SUBJECT: FORT CALHOUN STATION - NRC FOLLOWUP INSPECTION - INSPECTION  
REPORT 05000285/2010007; PRELIMINARY SUBSTANTIAL FINDING

Report Nos.: 05000285/2010007

.1 IP 92701, "Followup": URI 05000285/2009006-03, "Failure to Update Flood Protection for Safety Related Buildings"

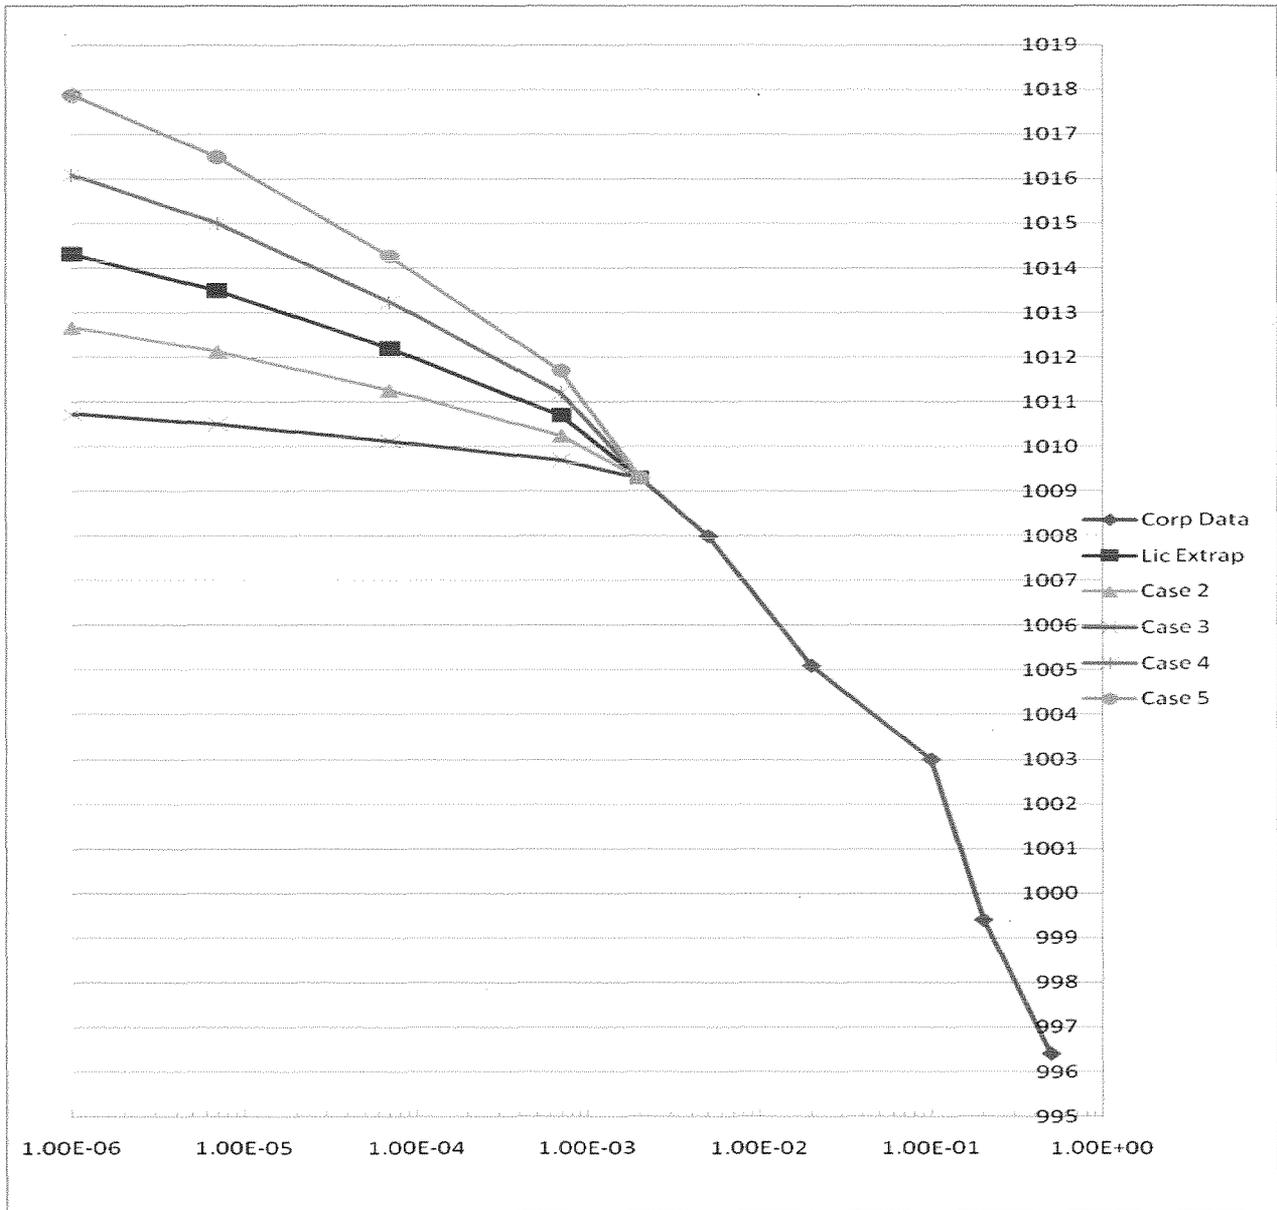
For the sensitivity cases, the analyst targeted the flooding elevation at the 1E-5/year point for comparison. At the 1E-5/year point on the Fort Calhoun flood hazard curve, the flood level was 1013.5 feet MSL. The analyst then constructed alternate curves, two above and two below this base curve. The Curves are shown on the following page. The curves were numbered Case 1 through Case 5. Case 3 was the licensee's estimate and was considered the best available information for this assessment.

Using data from the 5 curves, the analyst generated a delta-CDF for each case. The analyst summarized the results below:
